Application Number:	AWDM/0921/24	Recommendation: APPROVE subject to amended plans and expiry of the consultation period and subject to conditions.
Site:	40 - 46 Montague Street Worthing West Sussex BN11 3HB	
Proposal:	Two storey upward extension and remodelling of building to provide an aparthotel (Class C1) on upper floors with its entrance lobby to Portland Road at ground floor and the retention of retail space (Class E) at ground and part first floors, plus ancillary plant and equipment on the roof.	
Applicant:	Martin Millar (tor&co)	Ward: Central
Case Officer:	Stephen Cantwell

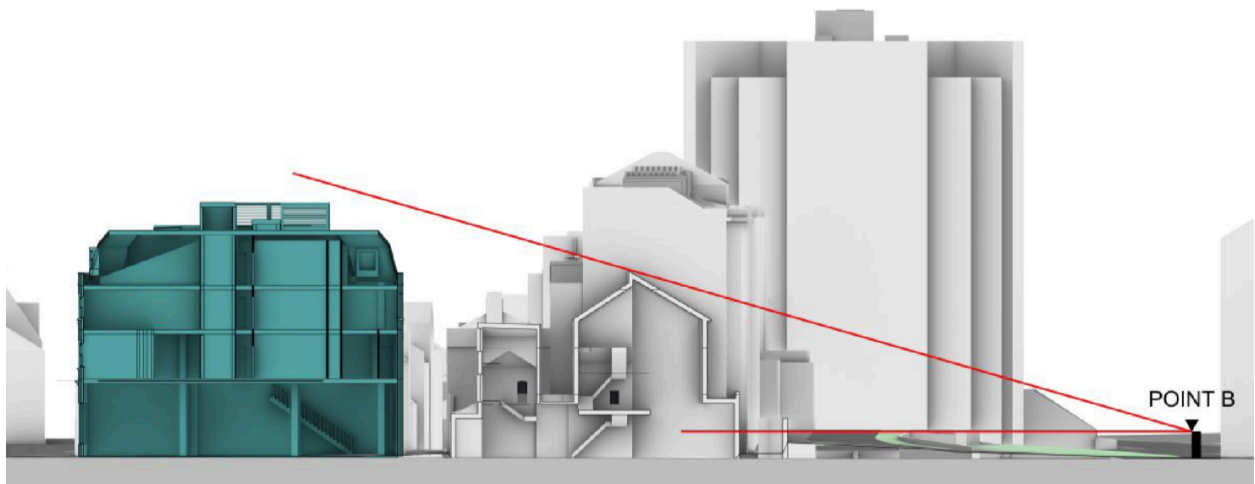
The proposal does increase the scale and height of the building by two floors and removes the oversailing corner detail as well as roof pediments, but Officers have worked extensively with the applicant to ensure that the redesigned building would continue to make a positive contribution to the Conservation Area and add to local character and distinctiveness.

The latest submitted plans have sought to reduce the overall height and dominance of the mansard roof by reducing its steepness and the number of dormer windows. Amended window arrangements give a more balanced and traditional appearance, using replacement timber sashes. The increased height of the building remains lower

To avoid unsightly air conditioning units these have been placed within a flat roof plant room. Whilst this looks prominent in the elevational drawings (see below) it has been set back a significant distance from the edge of the parapet (over 7.8 metres from the south and west elevations and 5.3 metres from the east elevation) and would be screened (partly by slatted louvres).

The agent has confirmed that the plant room would be painted/finished in a grey colour and this would assist to reduce its visual impact on the skyline. Details, including acoustic performance and maintenance would be required by condition.

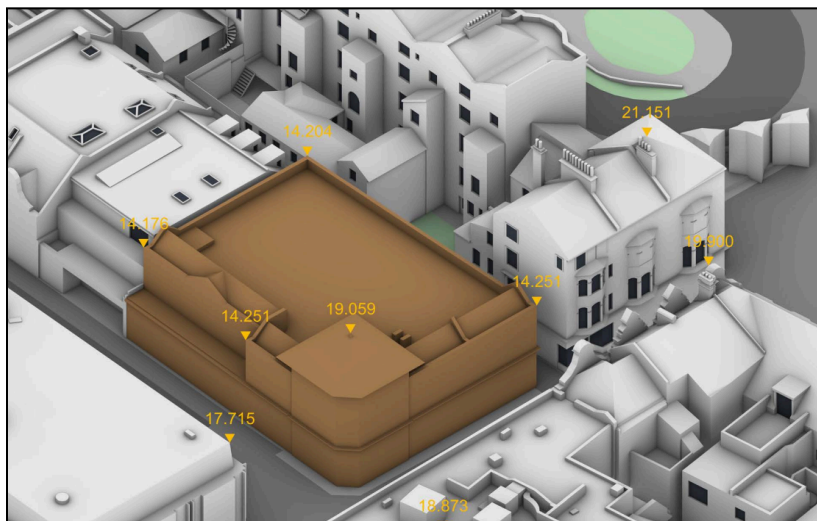
A key element of the negotiations has been the approach to the chamfered corner and how best to create an appropriate corner feature. The latest plans have created a tower feature (4 storeys high) with a metal cupola. The use of contrasting stone quoins creates a more generous corner detail, balanced with vertical emphasis and in general terms the amended scheme is a positive improvement.

However, there is some concern that the cupola is somewhat truncated and that the adjacent dormers (although balanced with fenestration below) are too close to the corner feature. Whilst, at street scene level this may not be an issue, Officers are discussing with the applicant options for making further changes to this important element of the scheme. The potential for a larger and higher curved cupola is to be explored to create a more distinctive corner feature. Members will be aware that this is a distinctive feature on many of Worthing's historic buildings (The Grand Victorian PH by the railway station and many pitched roof towers appear in Victorian villa buildings). Members will be updated at the meeting.

A condition is recommended requiring a number of architectural features to be shown at a 1:20 scale and to ensure that the building works, when undertaken, deliver a high quality and distinctive building required in this prominent town centre location.
